La Jolla Shores Planned District Advisory Board (LJSPDAB) APPLICANT PROJECT INFORMATION FORM

- Project Tracking System (PTS) Number/Accela "PRJ" Number and Project Name (only submitted projects to the Development Services Department can be heard as action items):
PRJ-1107808

PRJ-1107808 (2477 Avenida De La Playa, La Jolla 92037)

Responding to Project Issues Report 6 March 2024

1 Site Plan
1" = 10'-0"

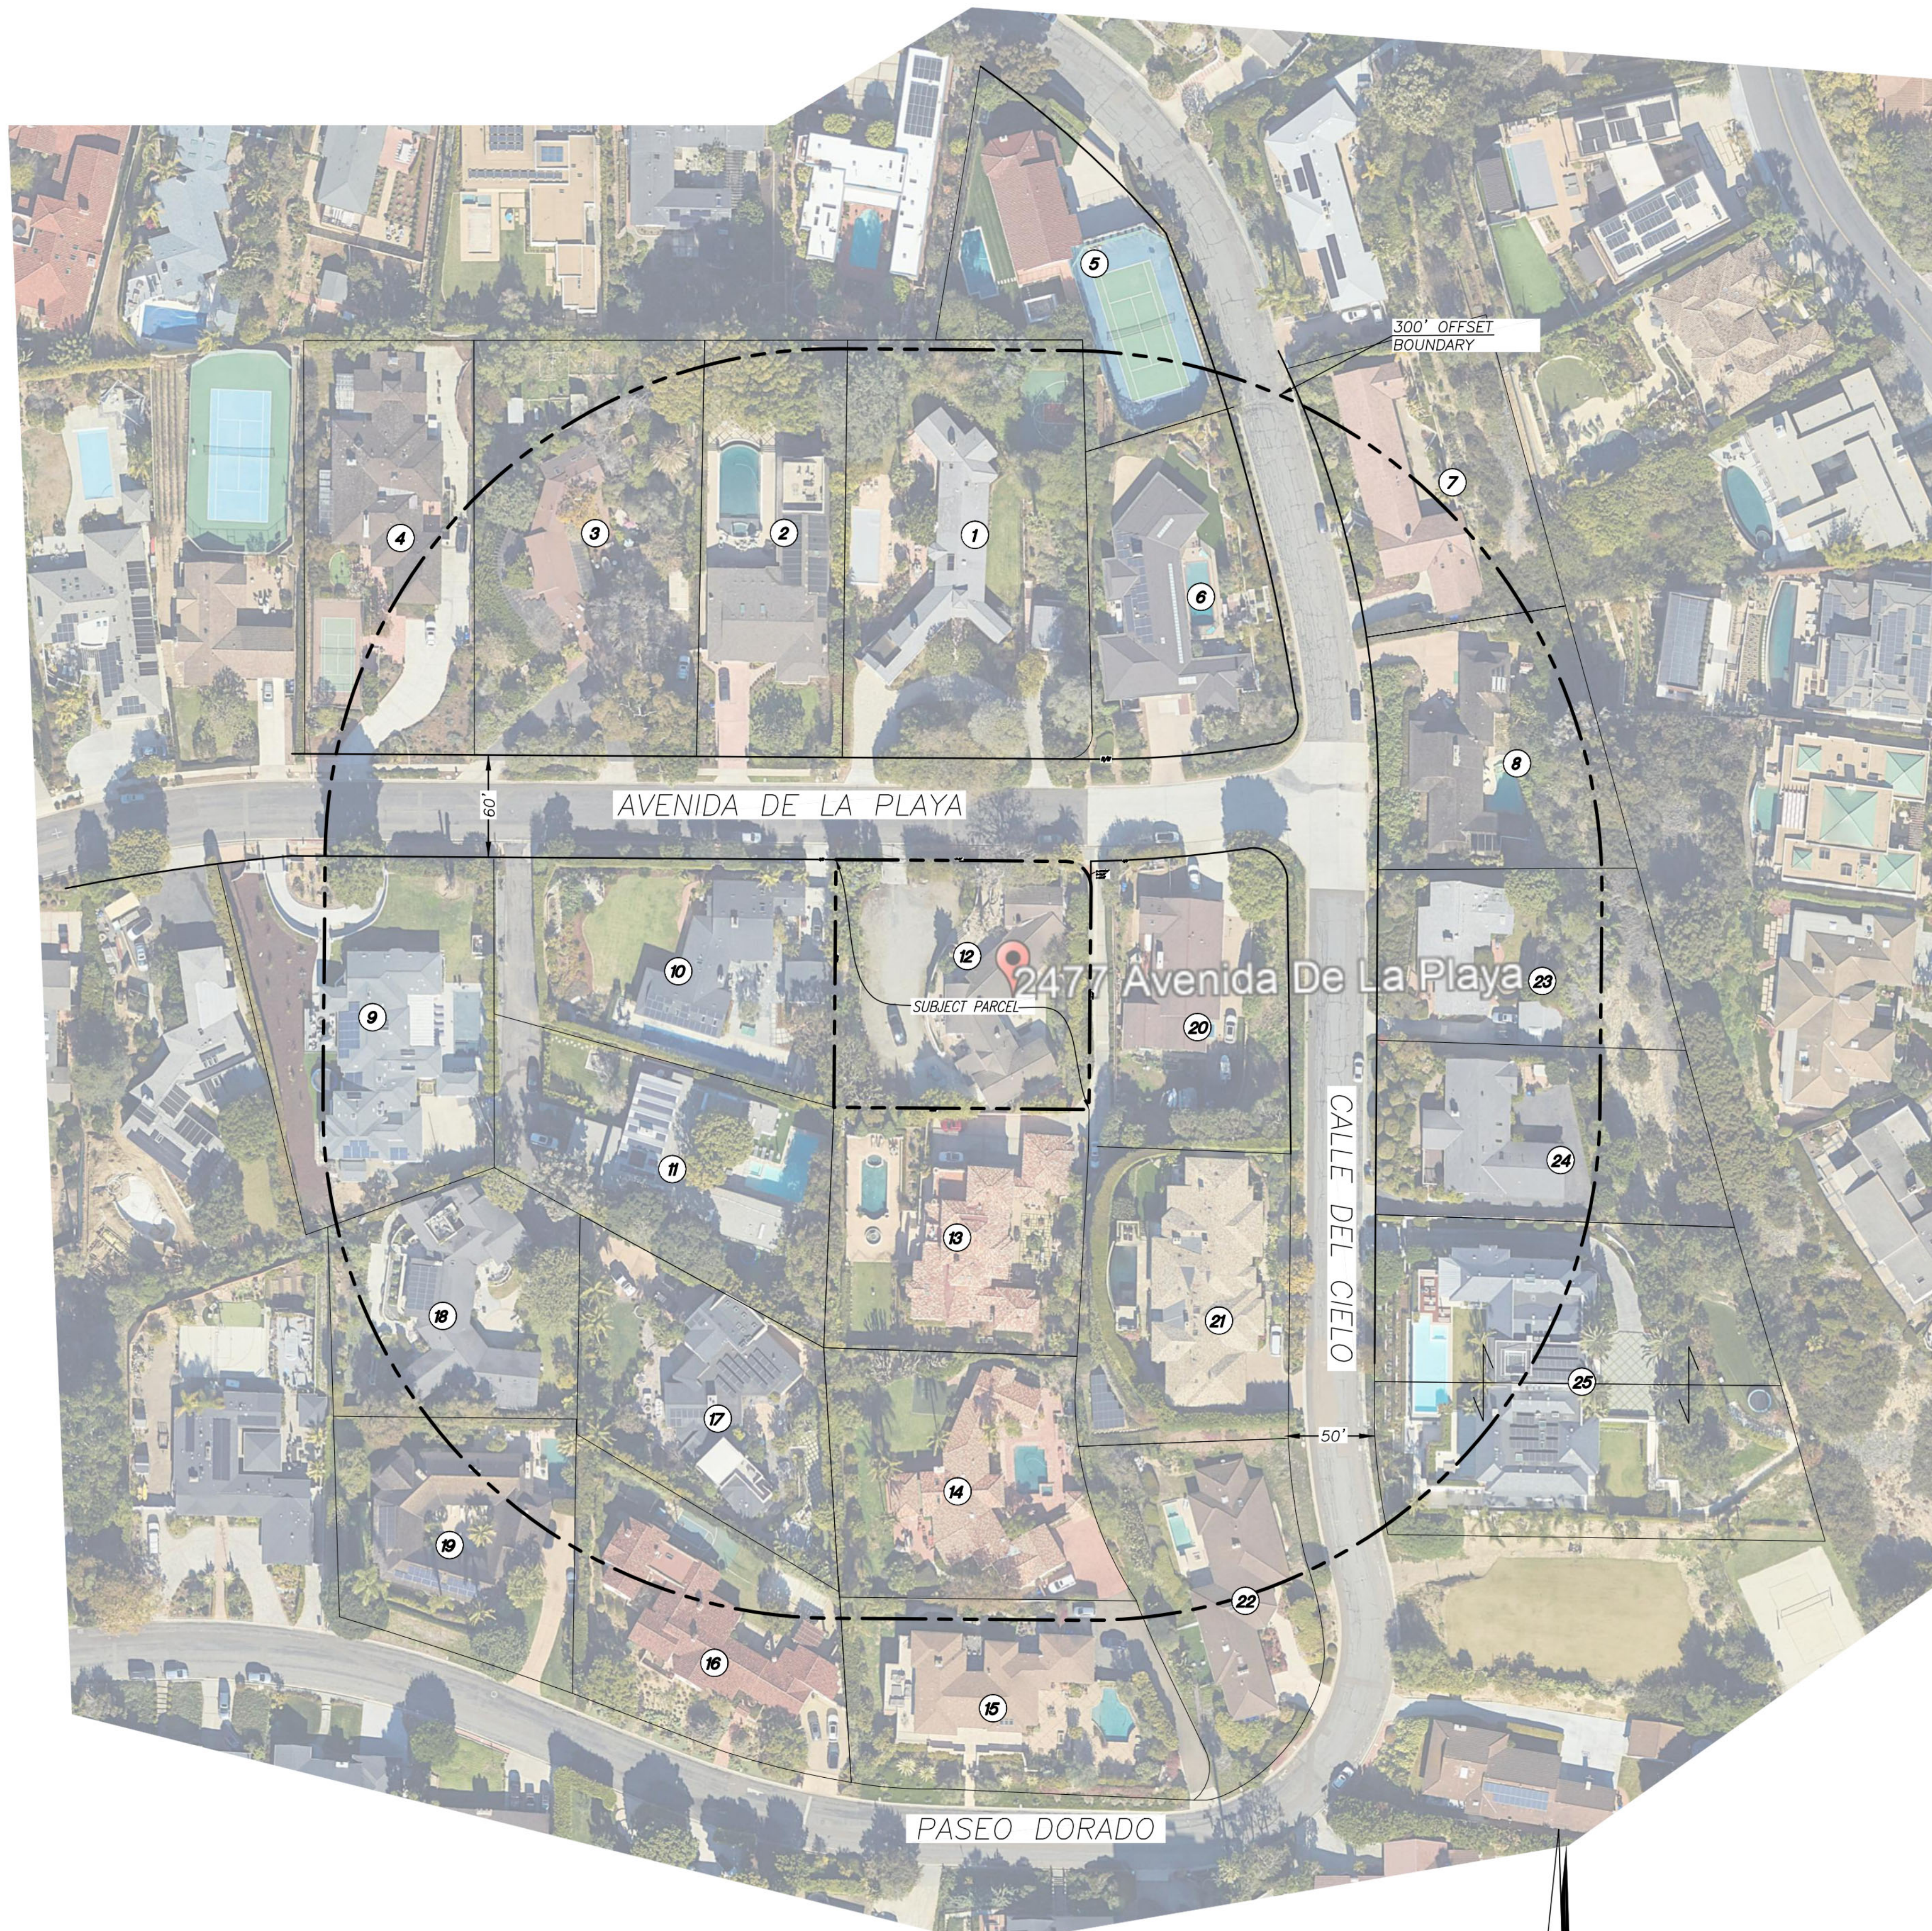
On sheet A1, site plan, a proposed 48" high stucco clad wall is proposed. The proposed wall appears to be within the required yards. On the site plan, please illustrate the location and dimension the distance to the property line. Please demonstrate how it conforms to section 142.0340 of the SDMC. In accordance with SDMC, please consider that:
- Per section 142.0340 (b) Retaining walls in visibility areas shall not exceed 3 feet in height except that a retaining wall

On the site plan, show, label and dimension the height and the location of the proposed walls and show how they conform to the SDMC.

Comment 00046: Revised front walls/fences and added site sections 2-4/A1. Also, see updated Key Notes 4 and 23 on sheet A1. Added Key Note 24 for Visibility Triangle. Walls within visibility triangle to be 36" tall maximum; See Key Note 4 on sheet A1 and see Civil Plan for additional information.

1 First Floor Plan
1/8" = 1'-0"

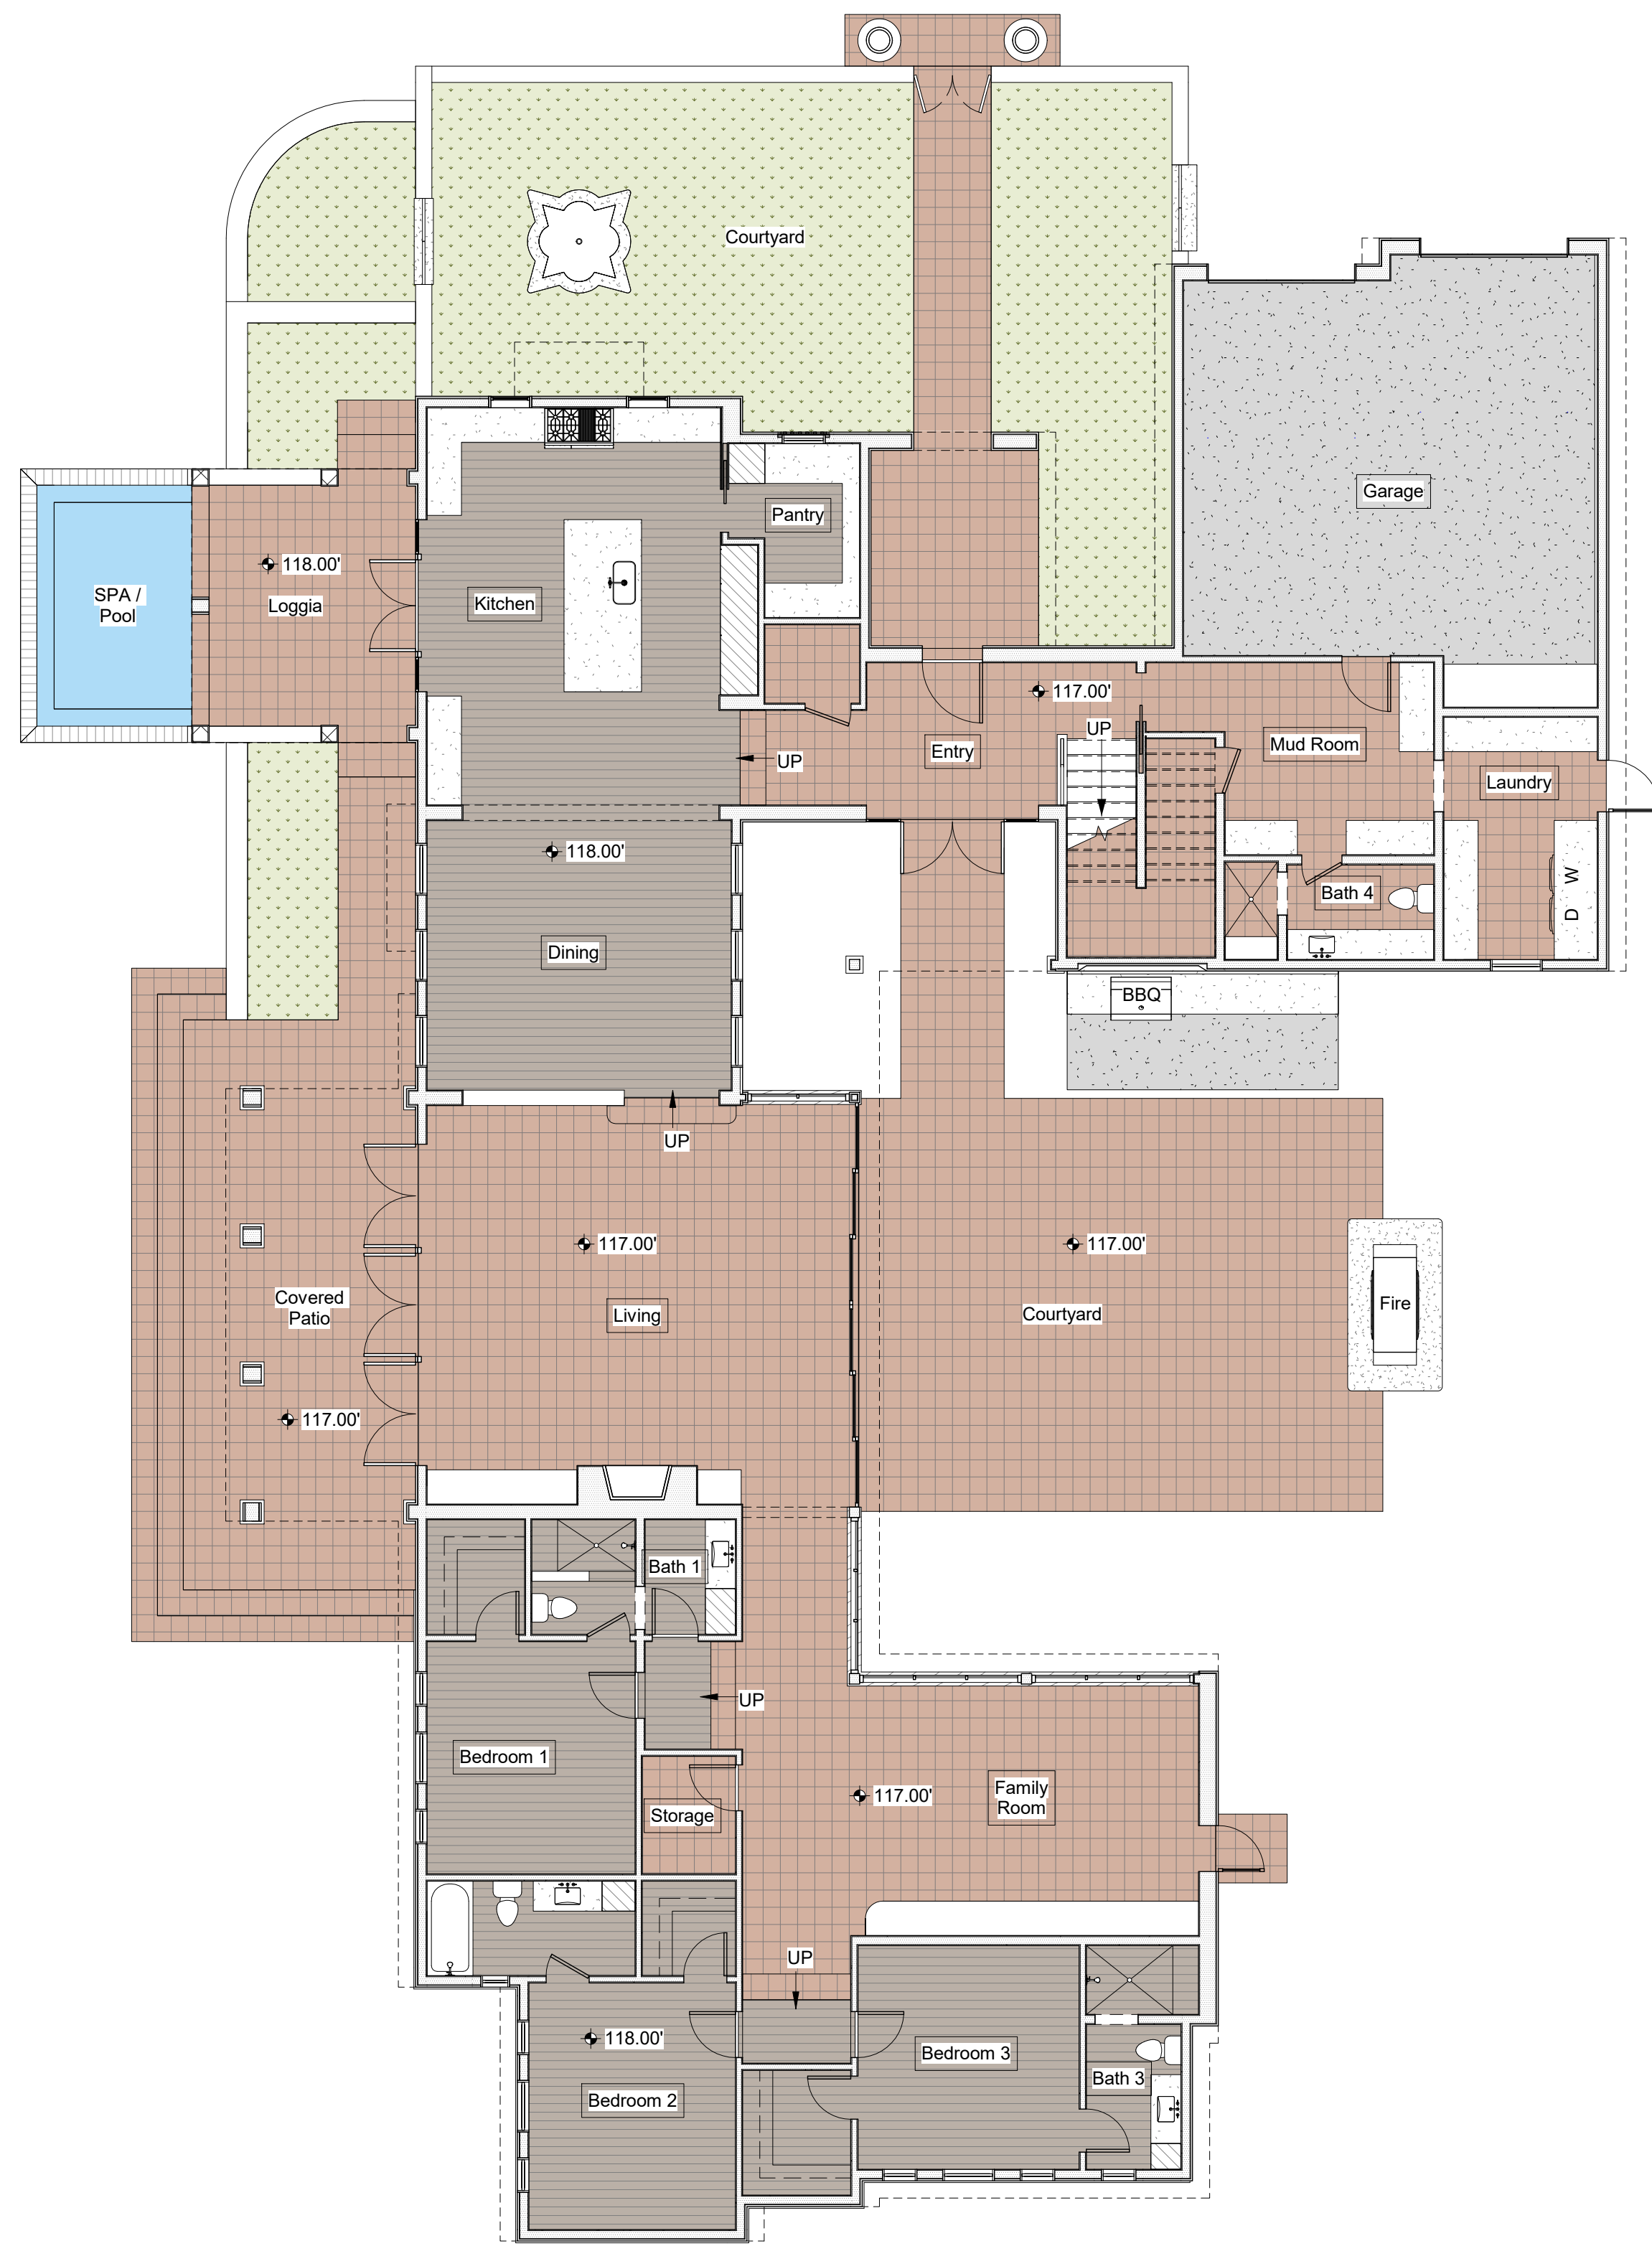
On the plans, please show, label, and dimension the parking space(s) consistent with Table 142-05K of Section 141.0302(b).

Comment 00047: Added Parking Spaces with dimensions in the Garage on plan 1/A2.
